**State of Wisconsin \ DEPARTMENT OF NATURAL RESOURCES**

January 23, 1995

SUBJECT: Estabrook Dam, Field File # 40.08, Dam Safety Inspection Report,  
Milwaukee County.

2) TREE REMOVAL AT CONCRETE DAM ABUTMENTS

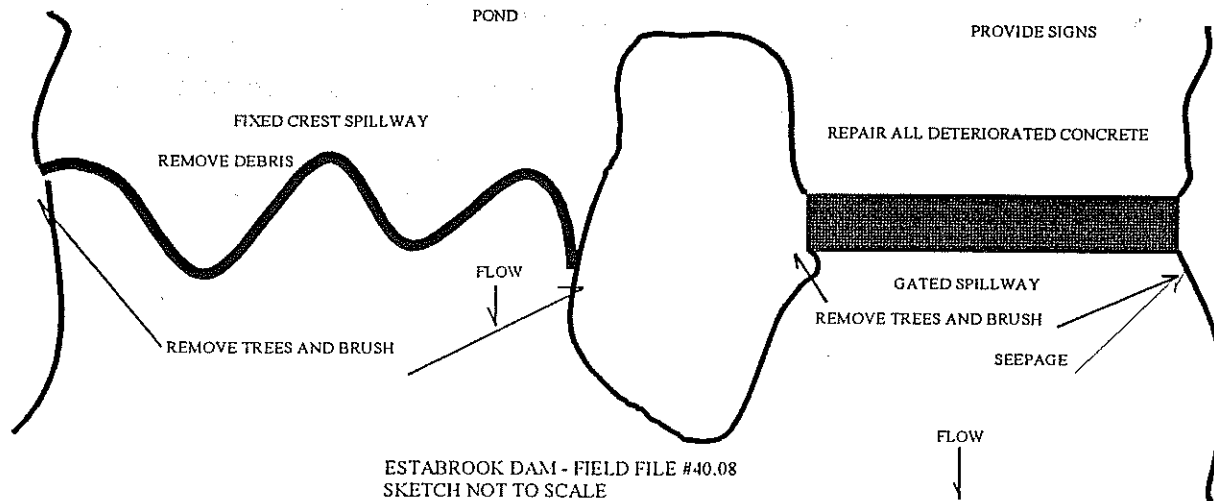
Remove all tress and brush at the right and left abutments of both the spillway sections of the dam. This includes both the gated and the fixed crest spillway sections.

Tree removal is important for a number of reasons. Trees can topple over in a severe storm taking with them a portion of the earthen embankment. The root systems provide a path for seepage waters to follow through the embankment. Trees grow old, die and topple over and/or leave their root system in the embankment to rot and provide a path for seepage. Trees also shade the embankment and make it difficult for grass to become established. Grass has proven to be the best method for controlling erosion on earthen embankments. Tree roots have also proven to be attractive to burrowing animals for use as homes. Root systems have been known to penetrate concrete and masonry structures causing damage. All of these things lead to the same end, a risk of failure. By eliminating the trees from the embankment you reduce the risk of failure caused by tree growth.

Tree removal is to include the complete removal of the stumps and the roots, filling of the holes created with firmly compacted tight soils, adding topsoil and grass seed to establish grass growth. The embankment should then be mowed on a regular basis so that the growth does not exceed 6 inches at any time.
